STORM SEWER PLAN
VILLAGE ON THE PARWAY
VILLAGE PARKWAY VENTURE
 ALBERT H. H. ZEE ASSOCIATES, INC., ENGINEERS
 CITY OF ADDISON, TEXAS

STORM SEWER PLAN
VILLAGE ON THE PARKWAY
VILLAGE PARKWAY VENTURE
 ALBERT H. HALFF ASSOCIATES, INC., ENGINEERS
CITY OF ADDISON, TEXAS

IRRIGATION, TELEPHONE & ELECTRICAL CONDUIT SLEEVE PLAN

WATER & SANITARY SEWER PLANS						
VILLAGE ON THE PARKWAY						
VILLAGE PARKWAY VENTURE						
ALBERT H. HALFF ASSOCIATES, INC. - ENGINEERS						
CITY OF ADDISON, TEXAS						
DESIGN	DRAWN	DATE	SCALE	NOTES	FILE	NO.
AHH	T.P.	MAY 1978	1"=50'	6143	4110	1960

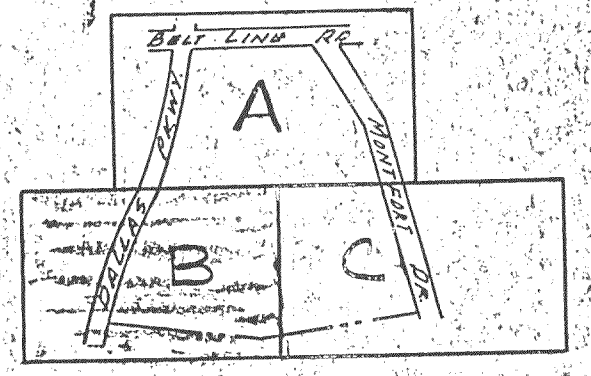
1/4/79 REVISED TO CONFORM WITH
 A-C GRADING PLAN

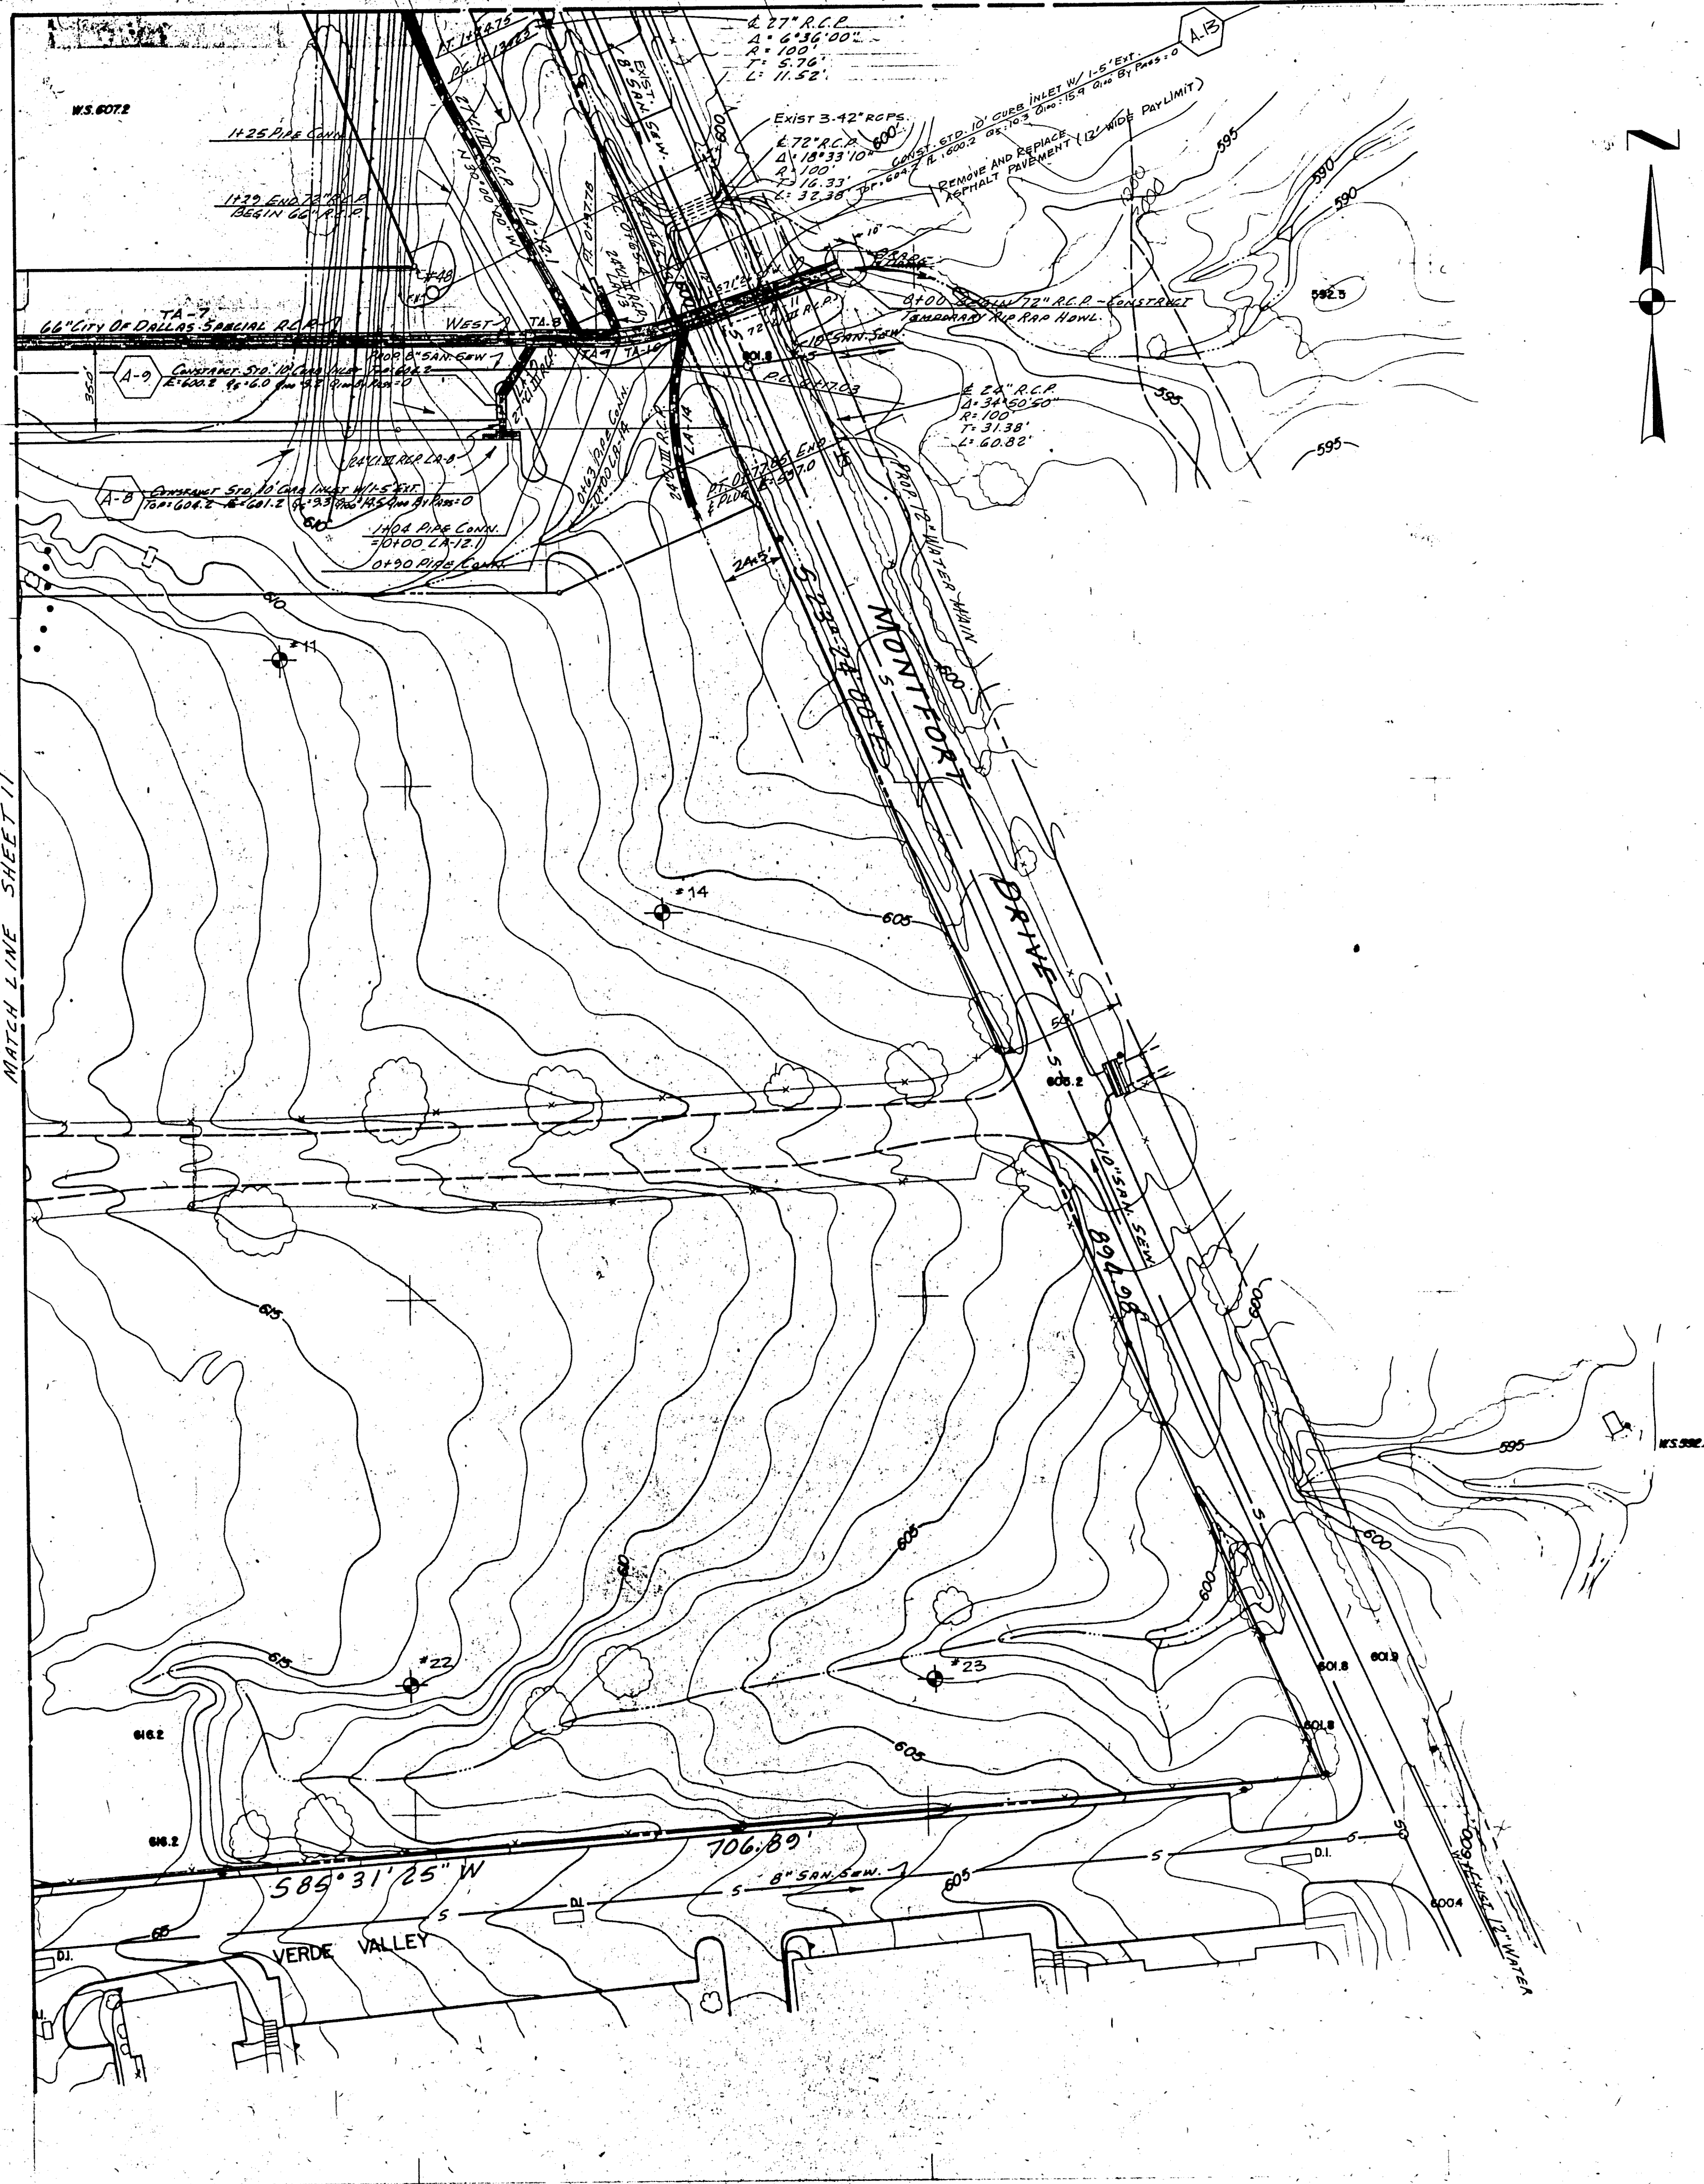
Added Lot Corners & Islands for 24" Installation

STORM SEWER PLAN						
VILLAGE ON THE PARKWAY						
VILLAGE PARKWAY VENTURE						
ALBERT H. HALFF ASSOCIATES, INC. ENGINEERS						
CITY OF ADDISON, TEXAS						
DESIGN	DRAWN	DATE	SCALE	NOTES	FILE	NO.
A.H.H. ASSOC.	T.P.	MAY 1978	1" = 40'	6143

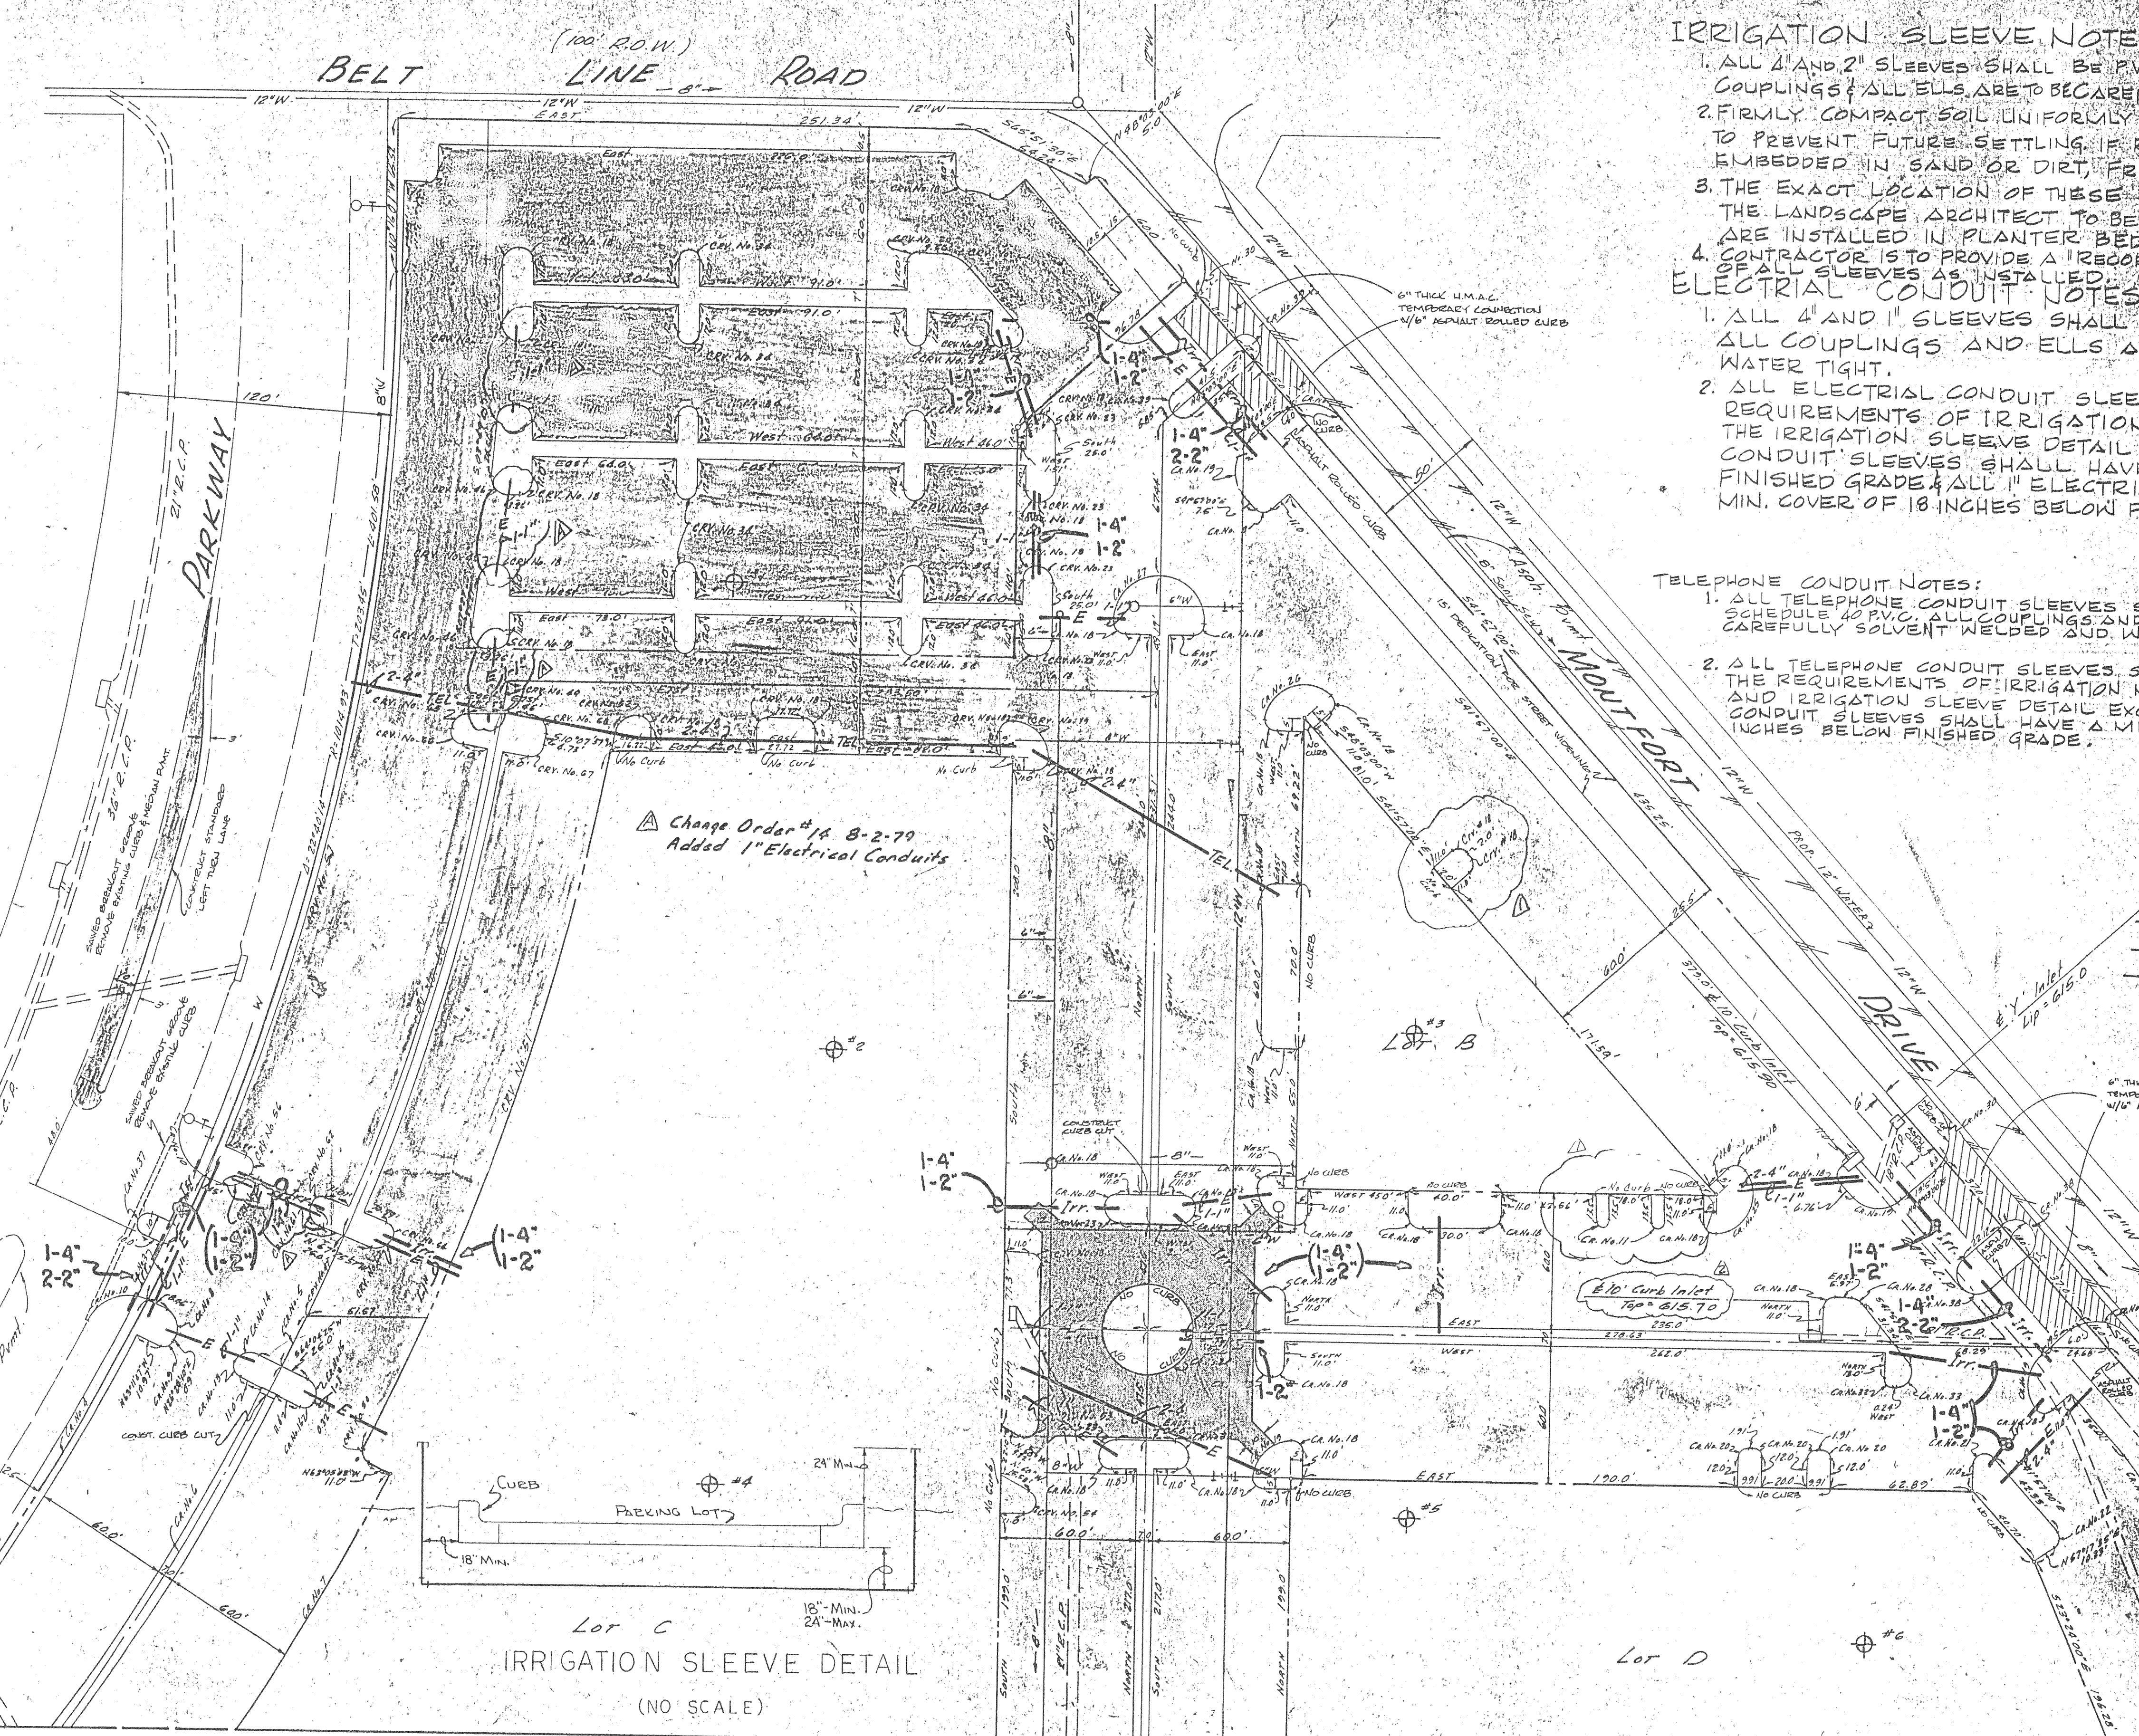
2.26-79 Storm Sewer for Second Installment
